# UNITED STATES PATENT AND TRADEMARK OFFICE

APPLICATION NO.	FILING DATE	FIRST NAMED INVENTOR	ATTORNEY DOCKET NO.	CONFIRMATION NO.
10/620,575	07/17/2003	Jang-Jin Yoo	8733.418.10	8871

**Office Action Summary**

## **DETAILED ACTION**

**FIG. 3**

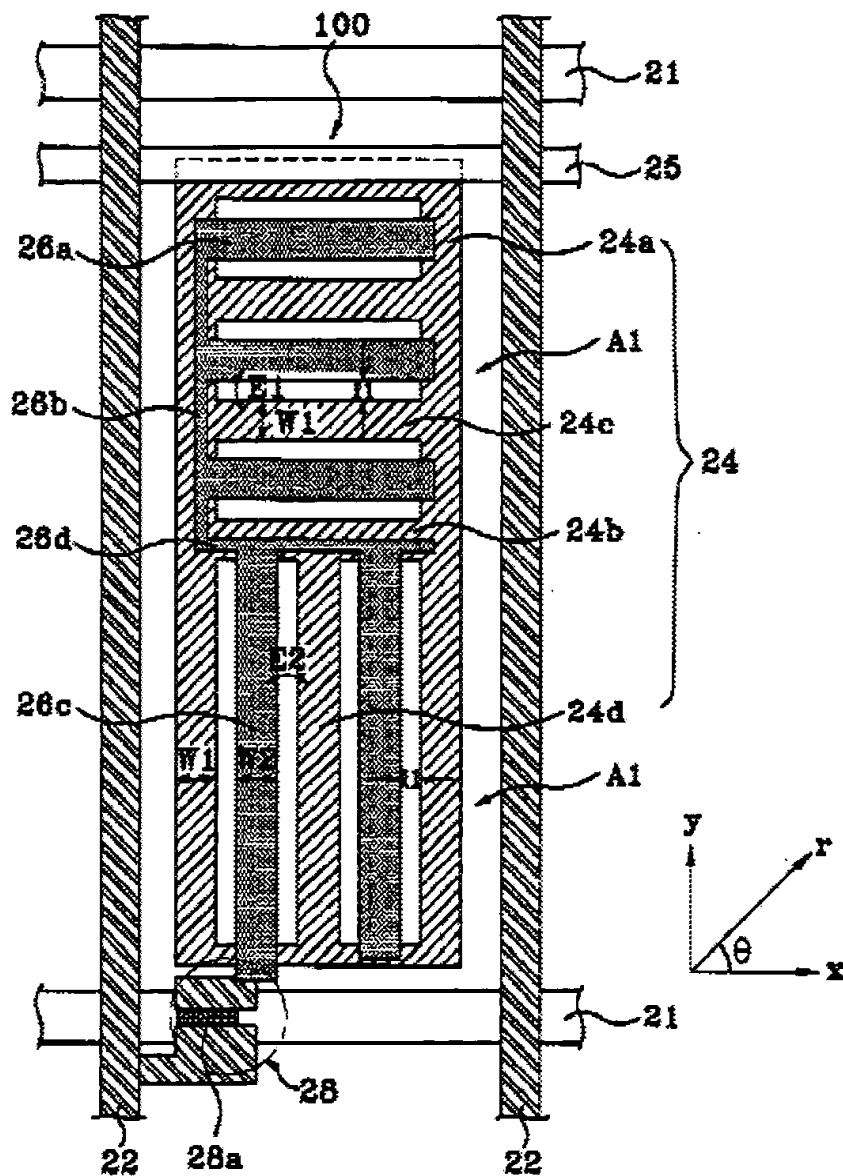
As to claims 18 and 31, Lee discloses (Abstract, Title, entire patent and first embodiment) an array substrate for an IPS-LCD device (col. 6, line 35 through col. 9, line 54), comprising:

a substrate; a gate line, 21, on the substrate; a data line, 22, perpendicular to the gate line; a thin film transistor, 28, at a crossing portion between the gate and data lines; a common line, 25, parallel to the gate line; a plurality of common electrodes, 24d, 24a,

and its counterpart on the left, extending perpendicular to the common line; a plurality of pixel electrodes, 26c and 26b, arranged alternately with the plurality of common electrodes; an auxiliary common electrode, 24c, perpendicularly contacting each of the common electrodes; and an auxiliary pixel electrode, 26d, perpendicularly contacting each of the pixel electrodes; wherein the auxiliary pixel electrode is spaced apart from the auxiliary common electrode; and pixel electrodes are on a same layer as said auxiliary pixel electrode.

As to claims 19 and 32, Lee discloses (Abstract, Title, entire patent and first embodiment) an array substrate for an IPS-LCD device (col. 6, line 35 through col. 9, line 54), comprising: a substrate; a gate line, 21, on the substrate; a data line, 22, perpendicular to the gate line; a thin film transistor, 28, at a crossing portion between the gate and data lines; a common line, 25, parallel to the gate line, the common line including first and second auxiliary common lines, 24d, 24a, and its counterpart on left, perpendicular to the common line; a plurality of common electrodes, 24b and 24c, extending perpendicular to the first and second auxiliary common lines; a plurality of pixel electrodes, 26a and its counterparts, arranged alternately with the plurality of common electrodes; an auxiliary common electrode, 24a (dual purpose), perpendicularly contacting each of the common electrodes; and an auxiliary pixel electrode, 26b, perpendicularly contacting each of the pixel electrodes, wherein the auxiliary pixel electrode is spaced apart from the auxiliary common electrode.

As to claim 20, Lee discloses (Abstract, Title, entire patent and first embodiment) an array substrate for an IPS-LCD device (col. 6, line 35 through col. 9, line 54), comprising: a substrate; a gate line, 21, on the substrate; a data line, 22, perpendicular to the gate line; a thin film transistor, 28, at a crossing portion between the gate and data lines; a common line, 25, parallel to the gate line, the common line including a plurality of common electrodes, 24d, 24a, and its counterpart on the left, extending perpendicular to the common line; a plurality of pixel electrodes, 26c and its counterpart on the right, arranged alternately with the plurality of common electrodes; and a plurality of auxiliary electrodes, 24b, 24c, and 26d, connecting the plurality of common and pixel electrodes in a check pattern.

**FIG. 10**

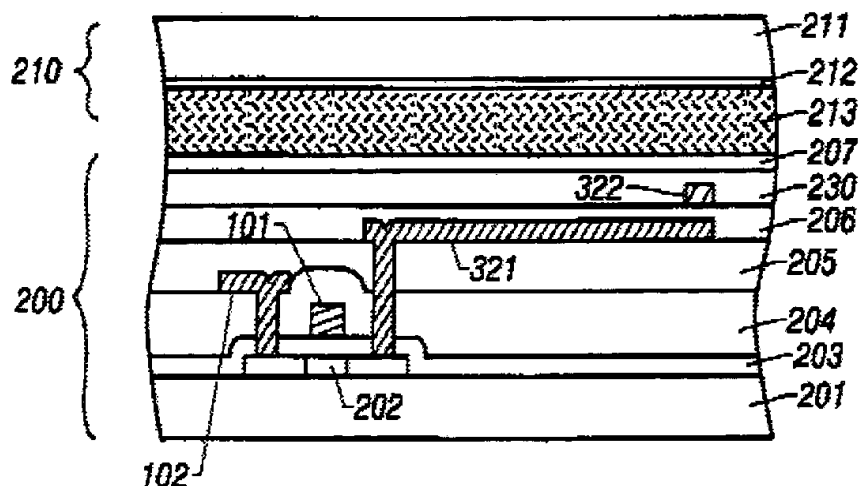
Hirakata teaches in the fourth embodiment (col. 8, line 56 through col. 9, line 34) a dielectric film, 205 (Applicant's first passivation layer), over the gate insulating layer, the data line and thin film transistor; a plurality of pixel electrodes, 321, on the first passivation layer; a second dielectric film, 206 (Applicant's second passivation layer), over the pixel electrodes; a common line, 322, on the second passivation layer to comprise a structure with increased aperture ratio (col. 8, lines 57-59).

Hirakata is evidence that ordinary workers in the art of liquid crystals would find the reason, suggestion, or motivation to add a first passivation layer over the gate insulating layer, the data line and thin film transistor; a plurality of pixel electrodes on the first passivation layer; a second passivation layer over the pixel electrodes; a common

Therefore, it would have been obvious to one having ordinary skill in the art of liquid crystals at the time the invention was made to modify the LCD of Lee with the first passivation layer over the gate insulating layer, the data line and thin film transistor; a plurality of pixel electrodes on the first passivation layer; a second passivation layer over the pixel electrodes; a common line on the second passivation layer of Hirakata to comprise a structure with increased aperture ratio.

**FIG. 7**

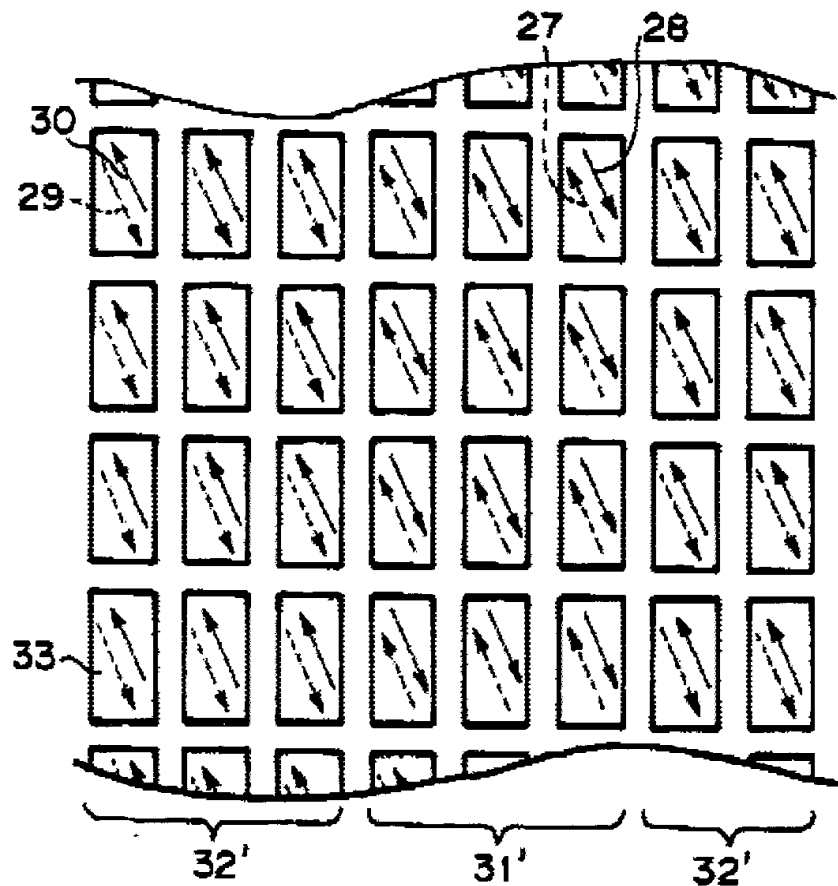
Okamoto teaches (Abstract, Title, entire patent) an alignment layer having first and second rubbing directions, the first and second rubbing directions corresponding to the first and second domains, respectively (col. 3, lines 25-59) to enhance image quality by preventing dependence on the viewing angle in the vertical and right-and-left directions.

Okamoto is evidence that ordinary workers in the art of liquid crystals would find the reason, suggestion, or motivation to add an alignment layer having first and second rubbing directions, the first and second rubbing directions corresponding to the first and second domains, respectively, to enhance image quality by preventing dependence on the viewing angle in the vertical and right-and-left directions.

Therefore, it would have been obvious to one having ordinary skill in the art of liquid crystals at the time the invention was made to modify the LCD of Lee with the

alignment layer having first and second rubbing directions, the first and second rubbing directions corresponding to the first and second domains, respectively of Okamoto to enhance image quality by preventing dependence on the viewing angle in the vertical and right-and-left directions.
